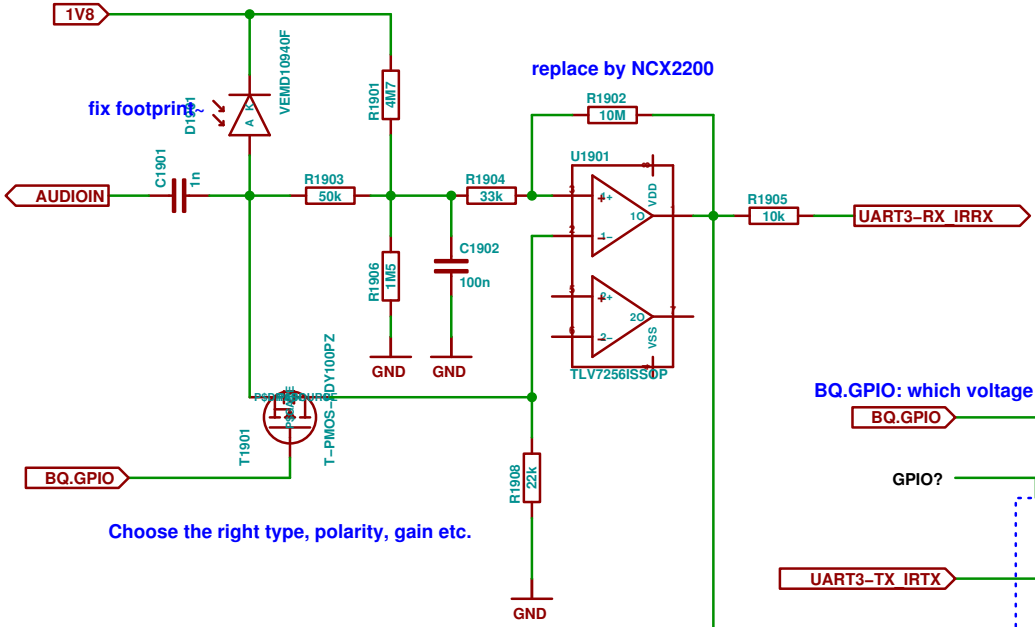
NOTE: I/O may be quite noisy

TODO: delete U1902

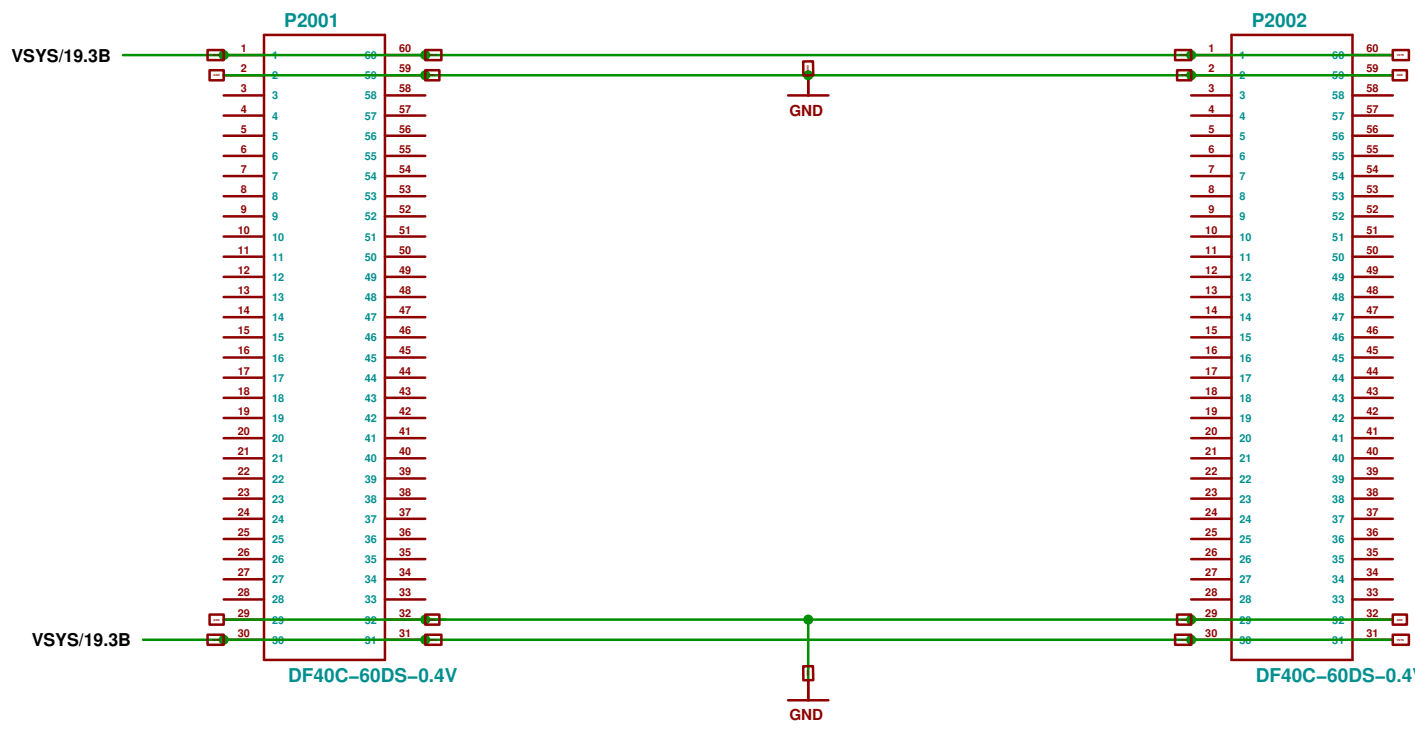
Pin assignment must be optimized for final component placement
we might have to switch to 80 or 100 pin connectors

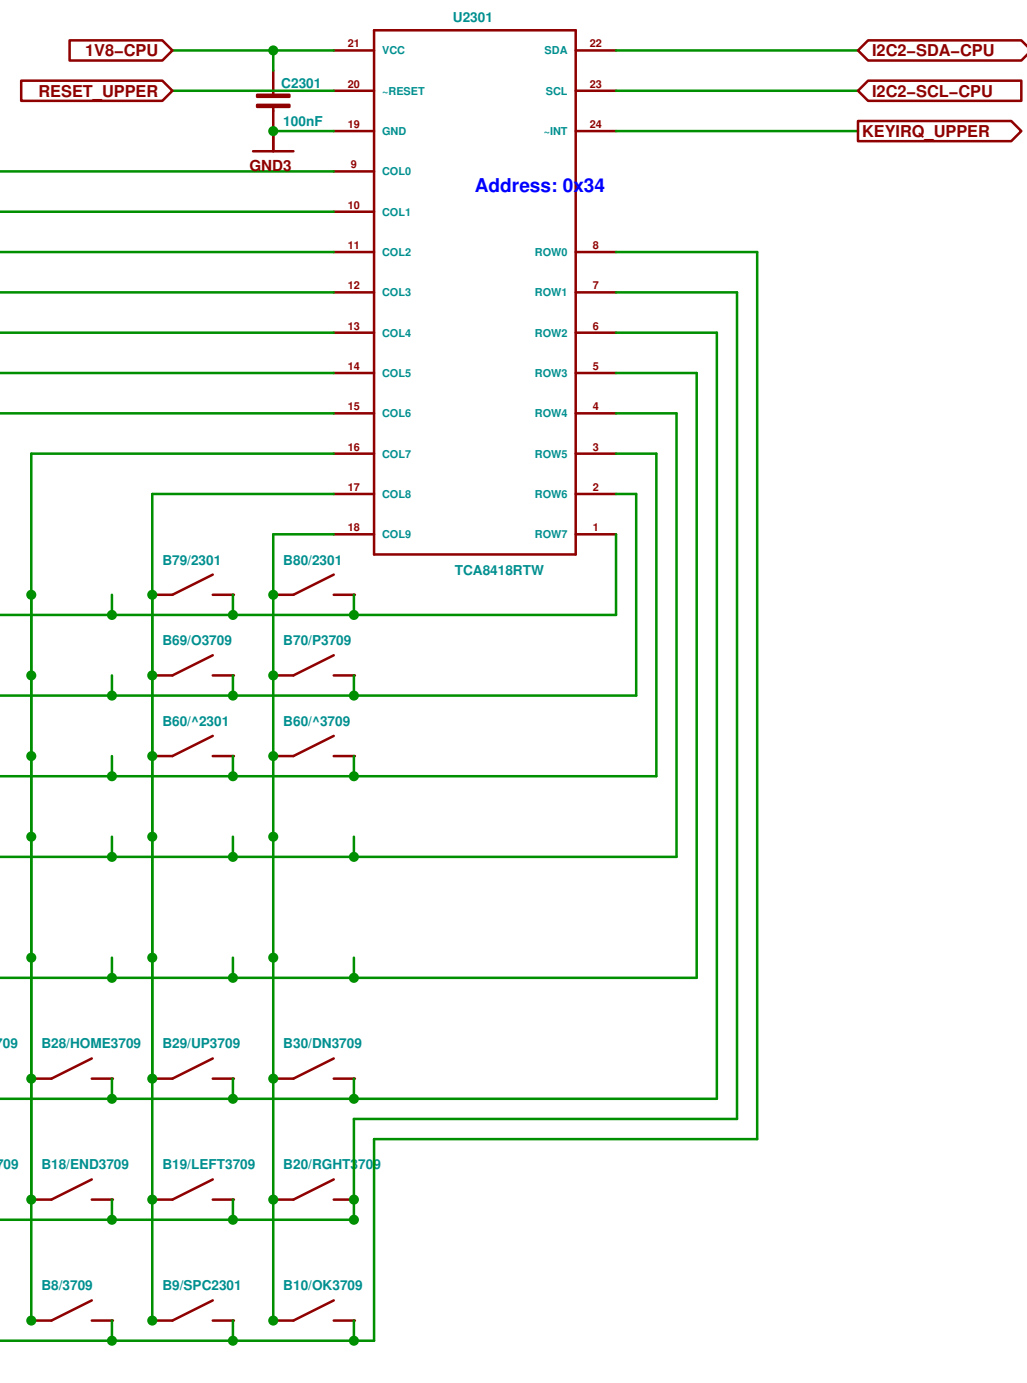
VOL+ and VOL- could drive FETs sitting in the matrix

replace by 2x RB521ZS8A30 for space constraints

- TODO: remove 3709 in comp ref
- TODO: remove keycap from comp ref
- TODO: sort out 6 "ext" buttons
- TODO: rearrange matrix to avoid diodes ?

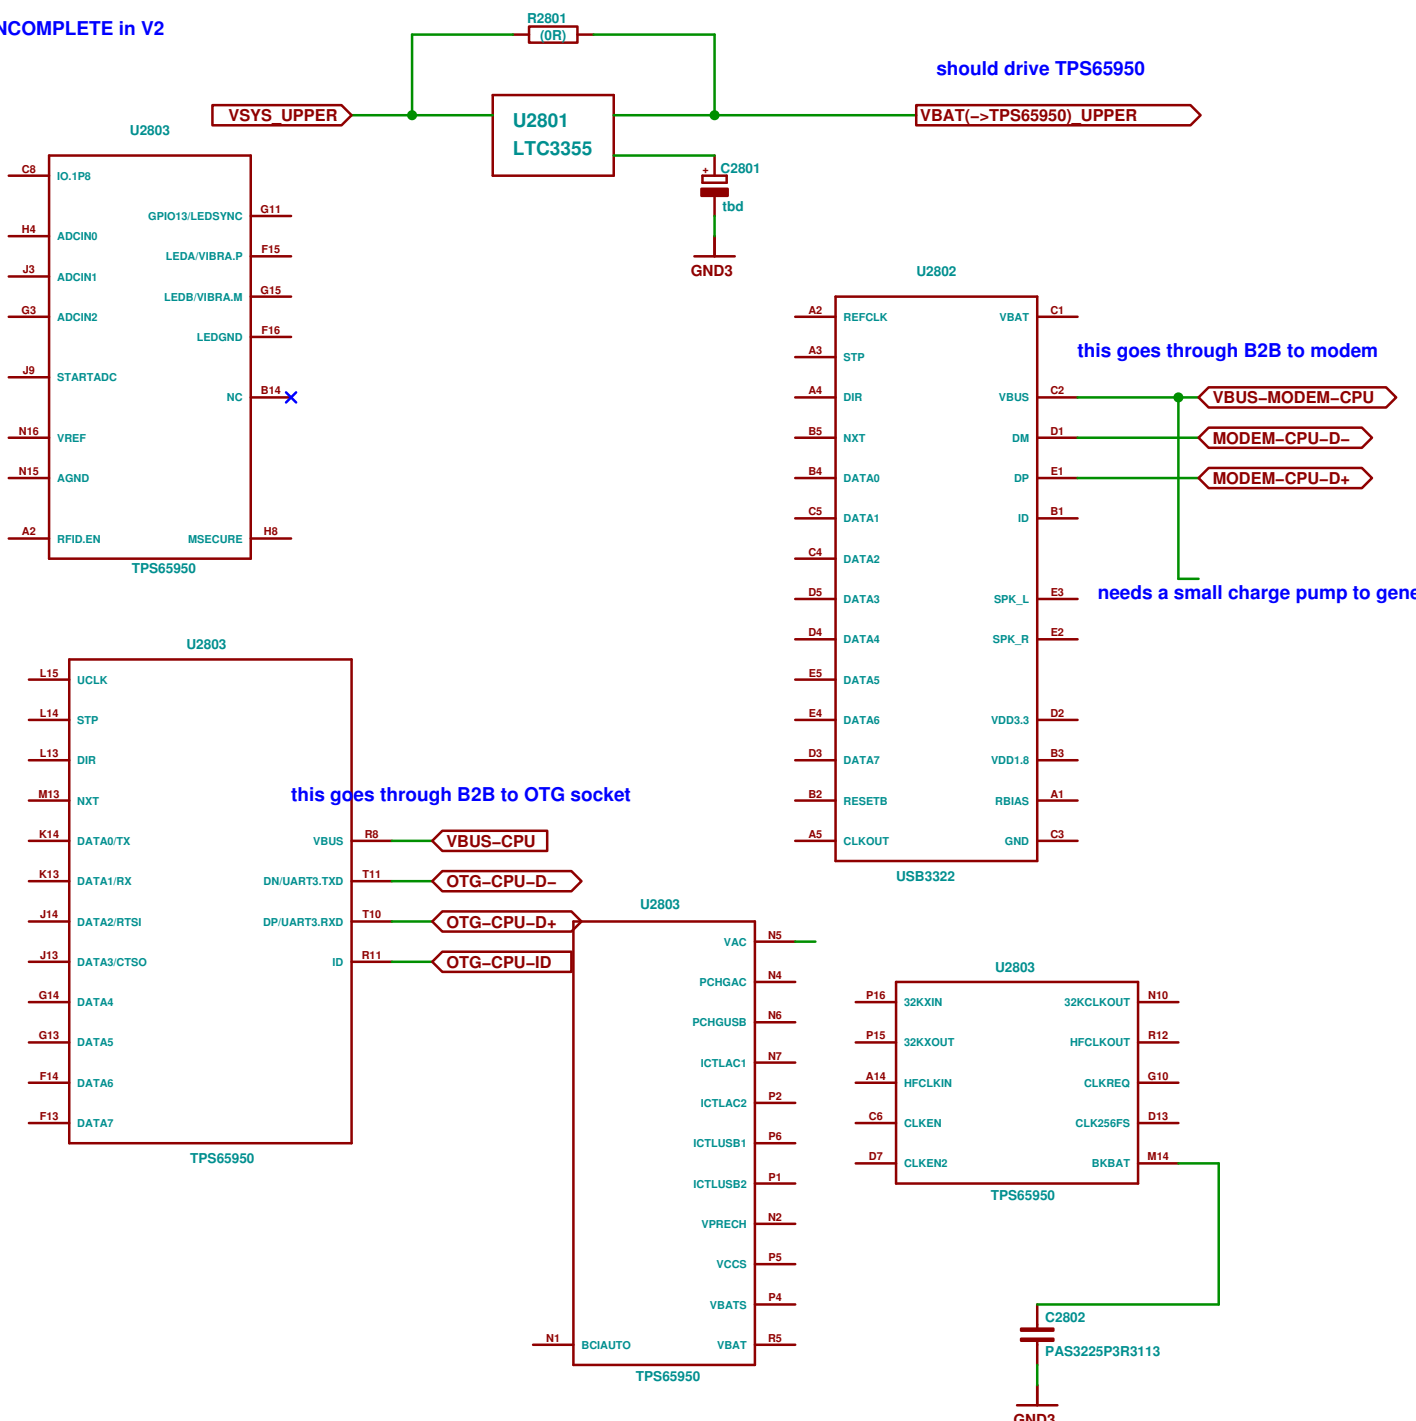
Adjust sense resistor+Z-Diode to voltage¤t
Check with data sheet of Sony ACX565AKM

INCOMPLETE in V2

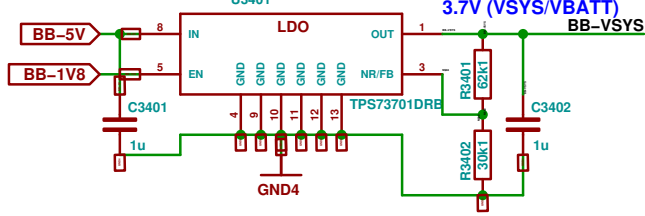
Ersetzen durch 2A buck converter
